15E ATWS Performance Evaluation

The information in this appendix of the reference ABWR DCD, including all subsections, tables, and figures, is incorporated by reference with the following departures.

Figure 15E-1a ATWS Mitigation Logic (ARI, FMCRD Run-In, RPT, Manual Initiation)

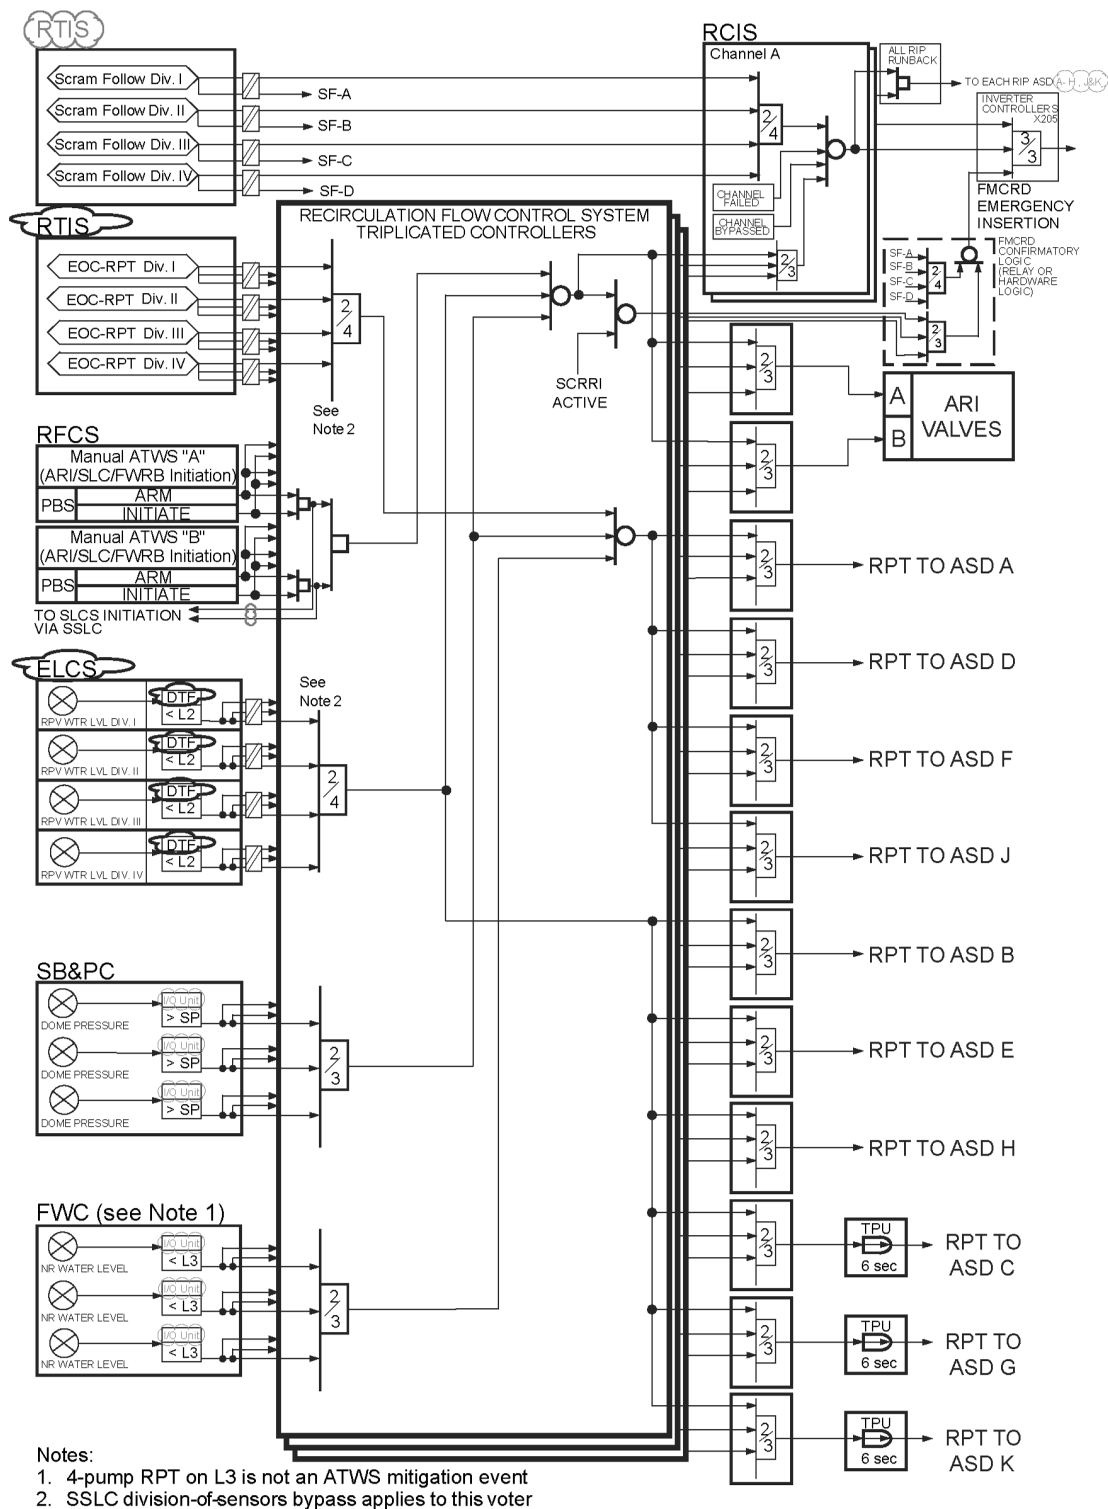
STD DEP T1 3.4-1 (Figures 15E-1a, 15E-1b, 15E-1c)

STD DEP Admin (Figure 15E-1a, Figure 15E-1b)

Figure 15E-1b ATWS Mitigation Logic (SLCS Initiation, Feedwater Runback)

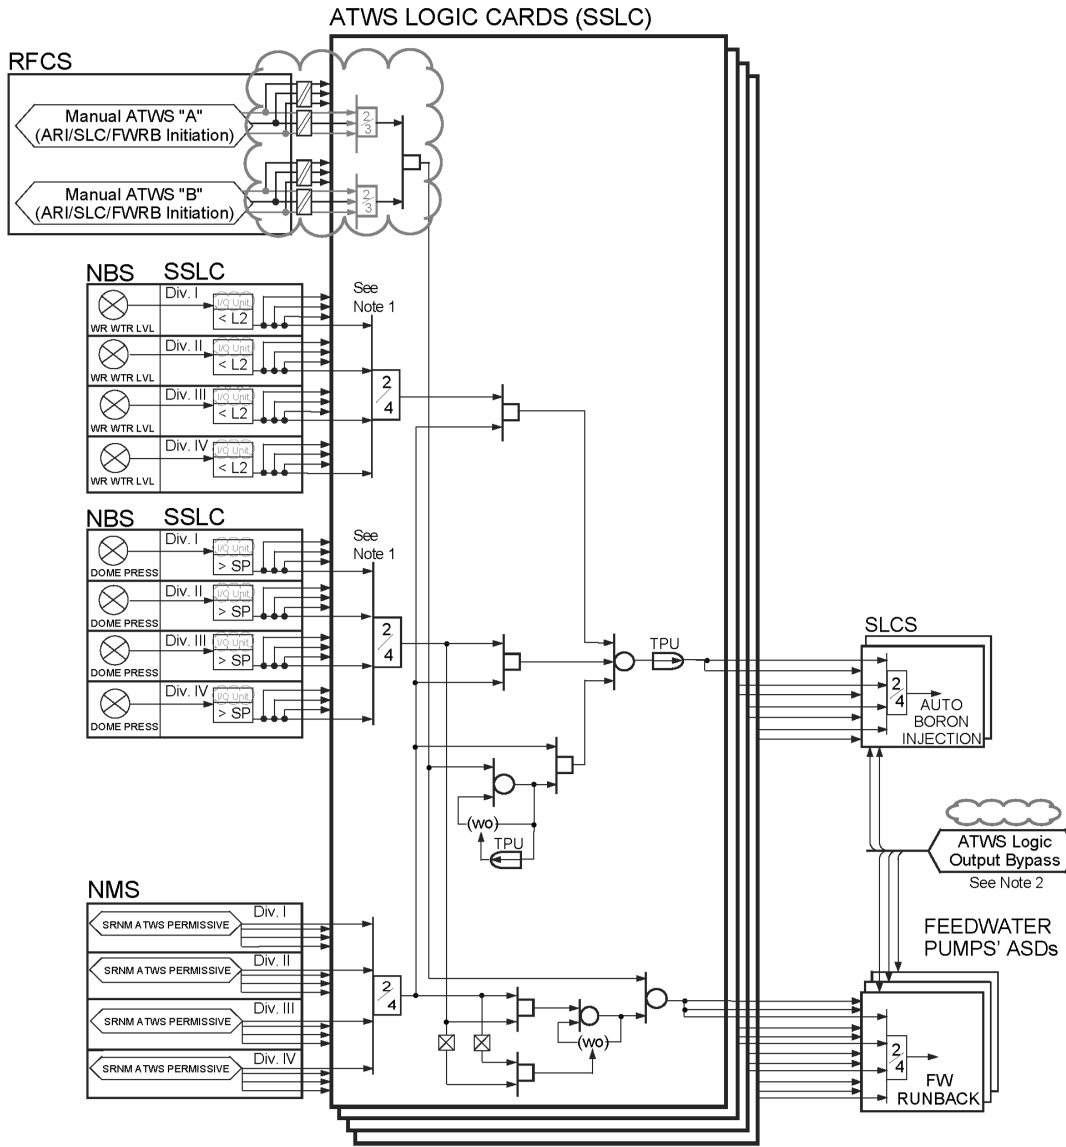
STD DEP 16.3-83 (Figure 15E-1b)
